RENESAS TECHNICAL UPDATE

Product Category	MPU/MCU		Document No.	TN-RZ*-A0131A/E	Rev.	1.00
Title	RZ/G2H, G2M V1.3, G2M V3.0, G2N and G2E Correction of section 36. Display Unit (DU)		Information Category	Technical Notification		
Applicable Product	RZ/G Series, 2nd Generation RZ/G2H RZ/G2M V1.3, V3.0 RZ/G2N RZ/G2E	Lot No.	Reference Document	RZ/G Series, 2nd Generation User's Manual: Hardware Rev.1.11 (R01UH0808EJ0111)		
		All lots

Correct the Block Diagram of section 36. Display Unit (DU) to show that FIFO can be selected from each DU channel.

Figure 36.1 Block Diagram of the DU [RZ/G2M V1.3, RZ/G2M V3.0]

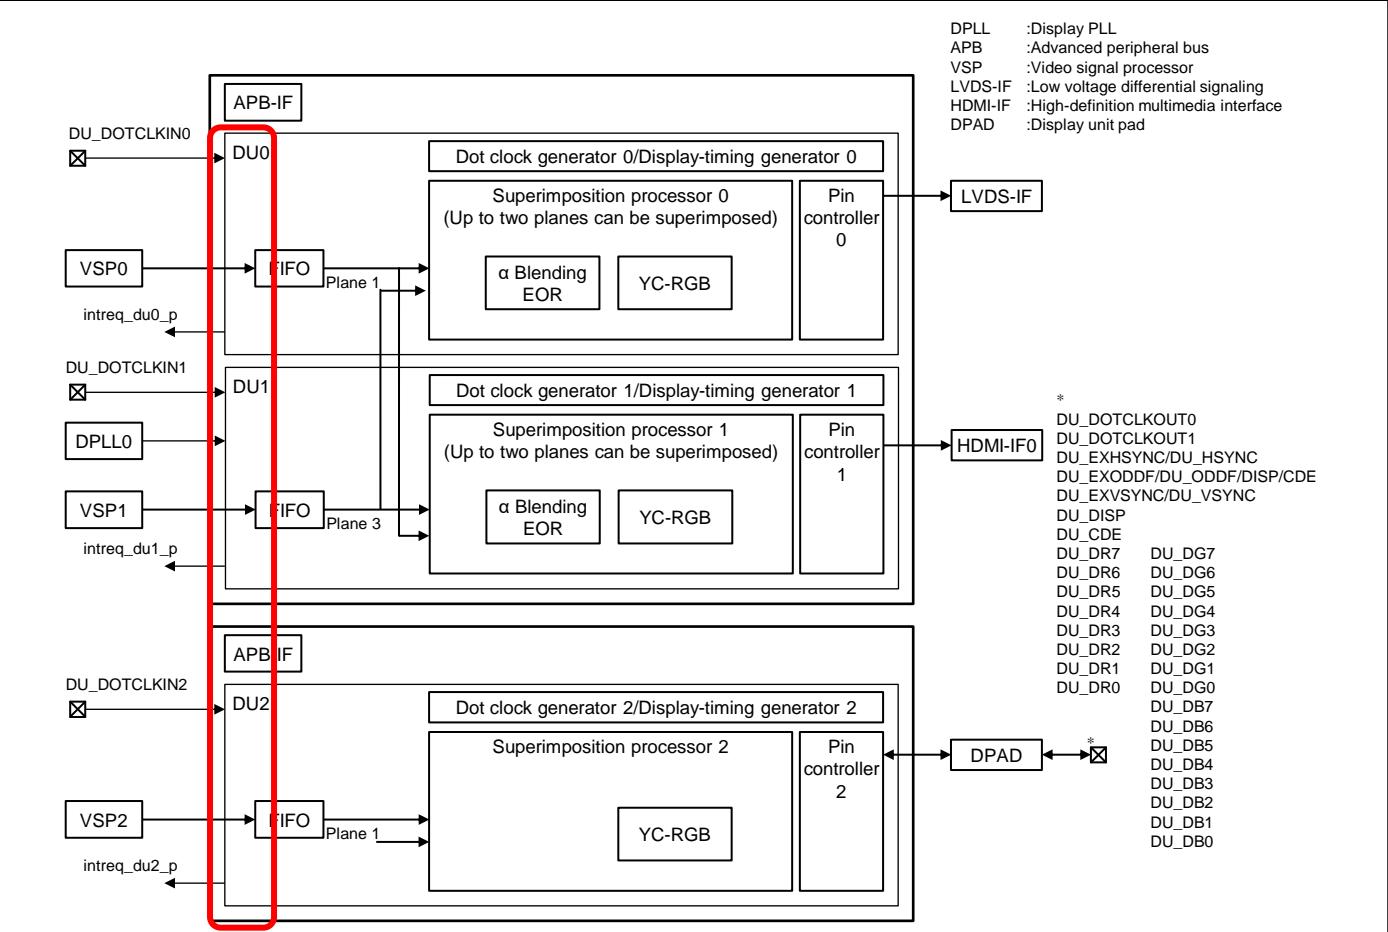
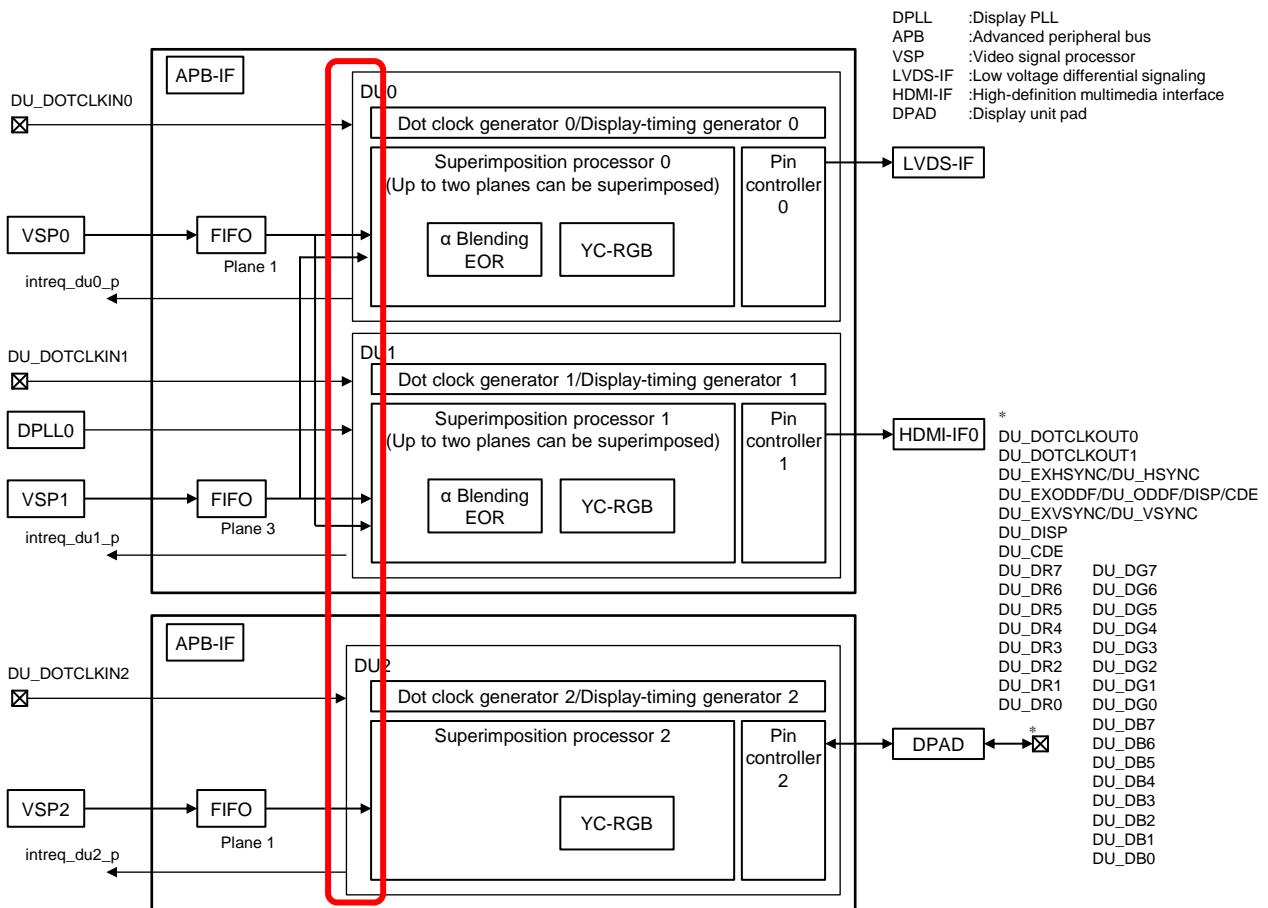
In the RZ/G2M V1.3, G2M V3.0 system, where the images of VSPD0 and VSPD1 are α blended using DU0, DU1 is not used, but DU1 is also running because the FIFO connected to VSPD1 is in DU1. Since DU0 and DU1 interrupts were used, the interrupt processing changed due to the dot clock frequency difference between DU0 and DU1, and FPS decreased.

The FIFO can be selected from the DIDSR0 register, but in the current Block Diagram, the FIFO appears to be fixed in DU0 or DU1 and is recognized as not being selectable. DU2 is fixed, but it will be modified to align the notation. Remove unnecessary arrows.

Figure 36.2 Block Diagram of the DU [RZ/G2H, RZ/G2N]

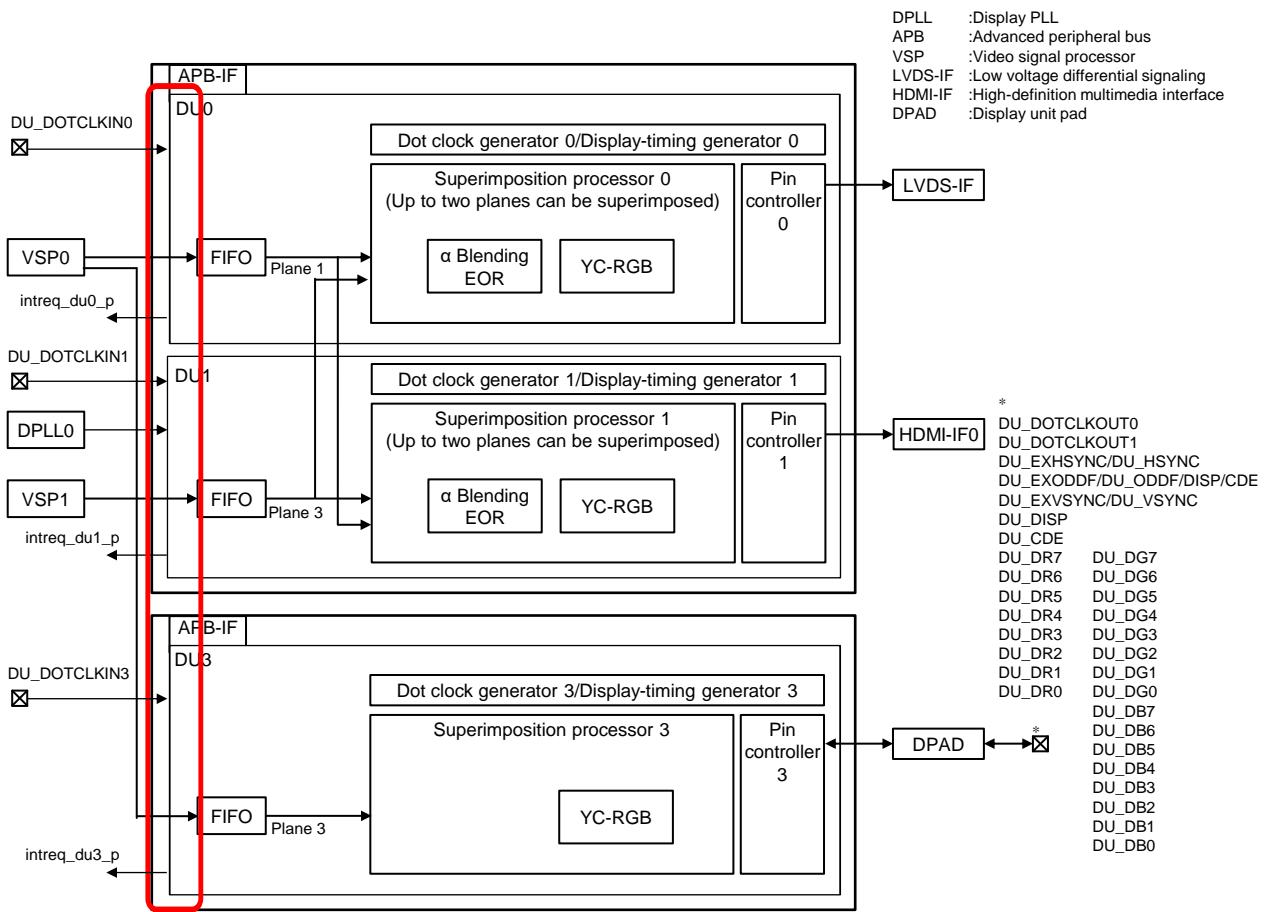
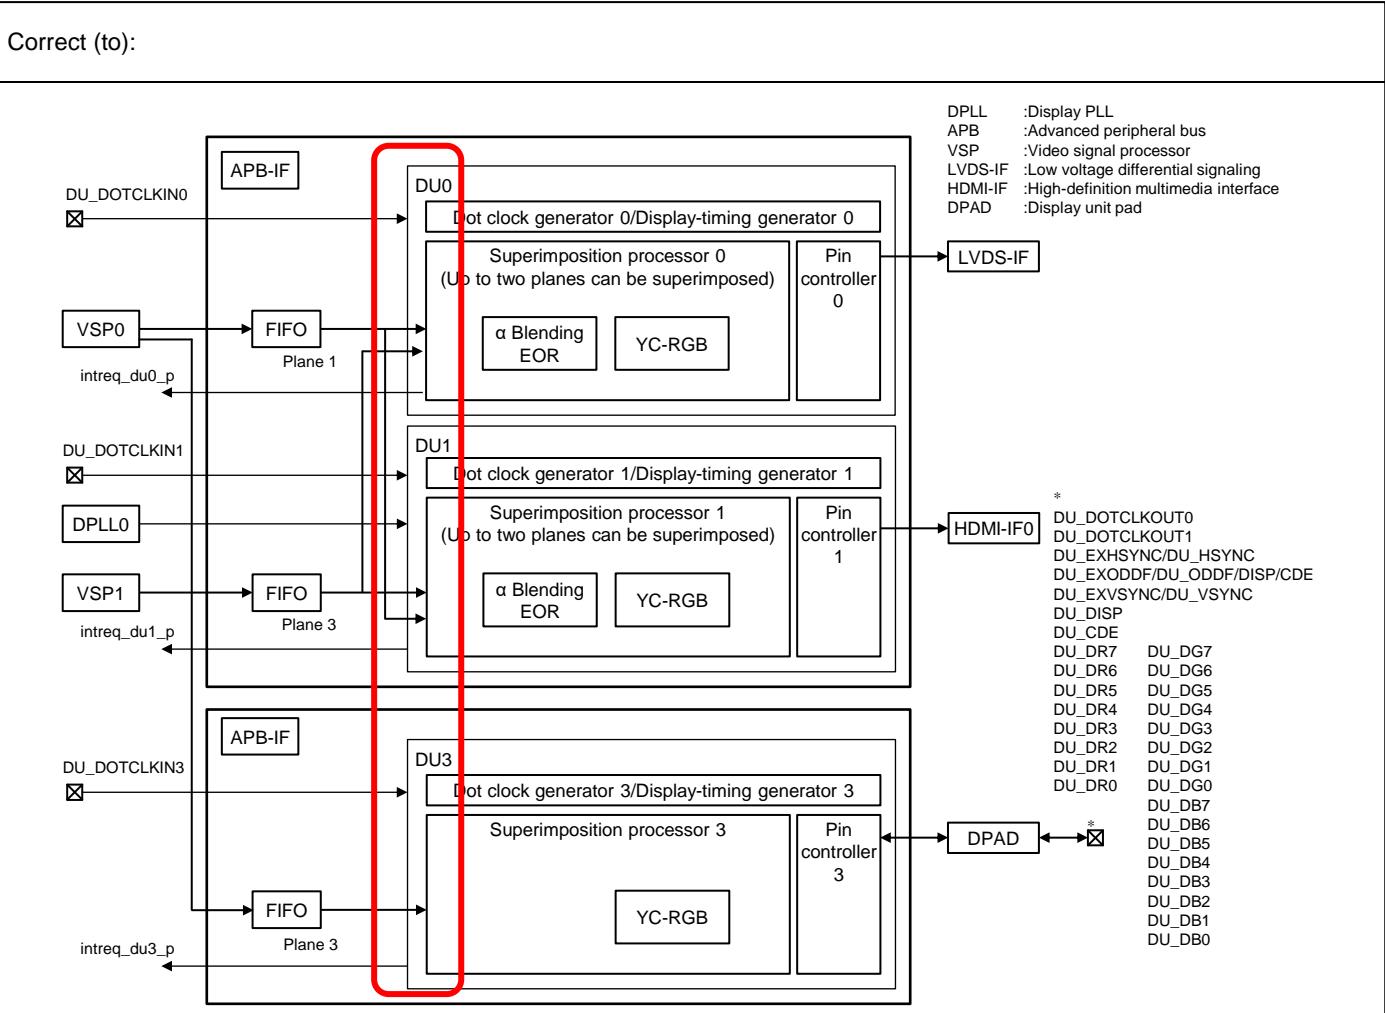
In the RZ/G2H, G2N system, where the images of VSPD0 and VSPD1 are α blended using DU0, DU1 is not used, but DU1 is also running because the FIFO connected to VSPD1 is in DU1. Since DU0 and DU1 interrupts were used, the interrupt processing changed due to the dot clock frequency difference between DU0 and DU1, and FPS decreased.

The FIFO can be selected from the DIDSR0 register, but in the current Block Diagram, the FIFO appears to be fixed in DU0 or DU1 and is recognized as not being selectable. DU3 is fixed, but it will be modified to align the notation.

Figure 36.3 Block Diagram of the DU [RZ/G2E]

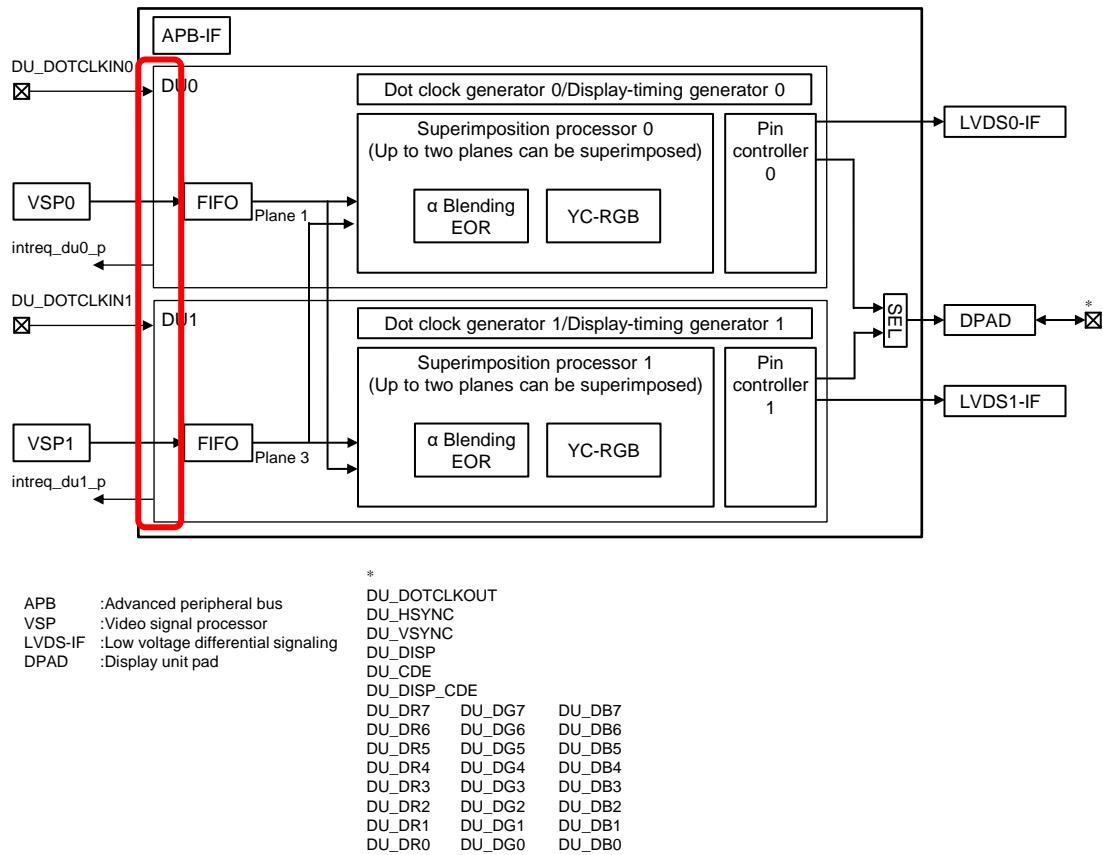
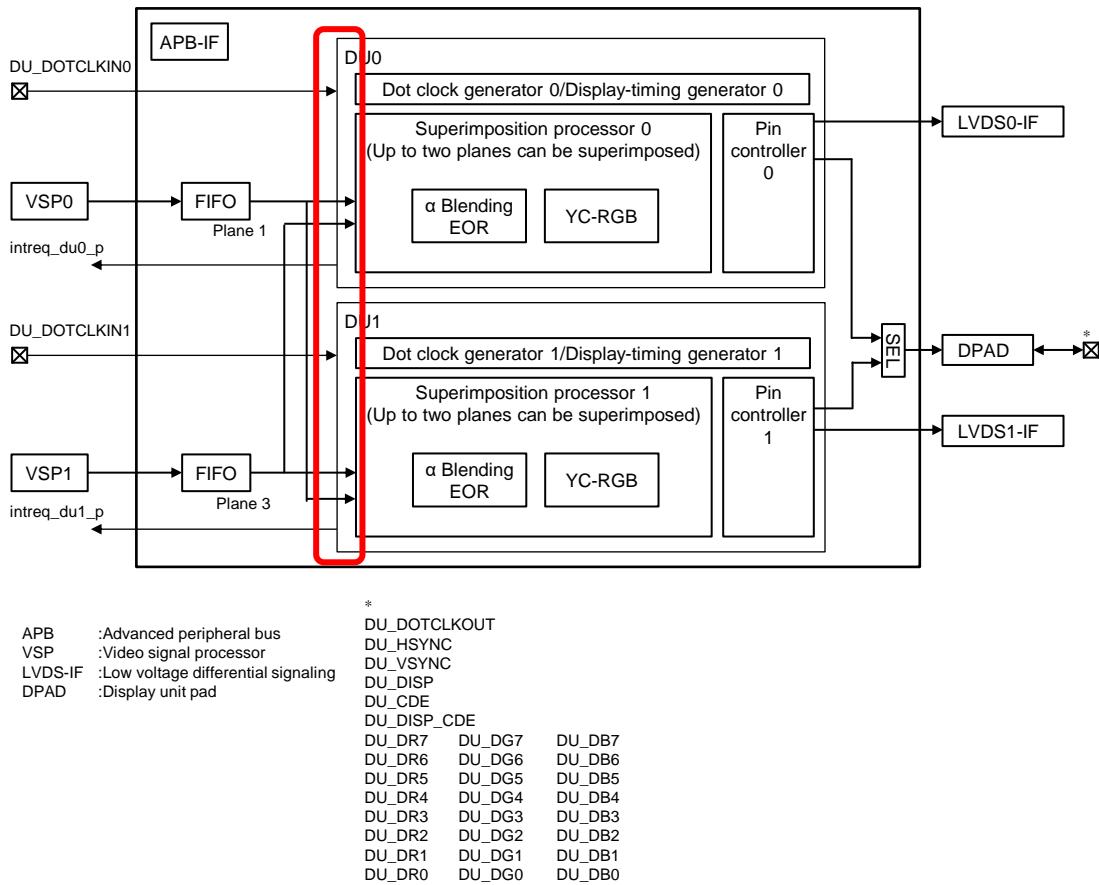
In the RZ/G2E system, where the images of VSPD0 and VSPD1 are α blended using DU0, DU1 is not used, but DU1 is also running because the FIFO connected to VSPD1 is in DU1. Since DU0 and DU1 interrupts were used, the interrupt processing changed due to the dot clock frequency difference between DU0 and DU1, and FPS decreased.

The FIFO can be selected from the DIDSR0 register, but in the current Block Diagram, the FIFO appears to be fixed in DU0 or DU1 and is recognized as not being selectable.
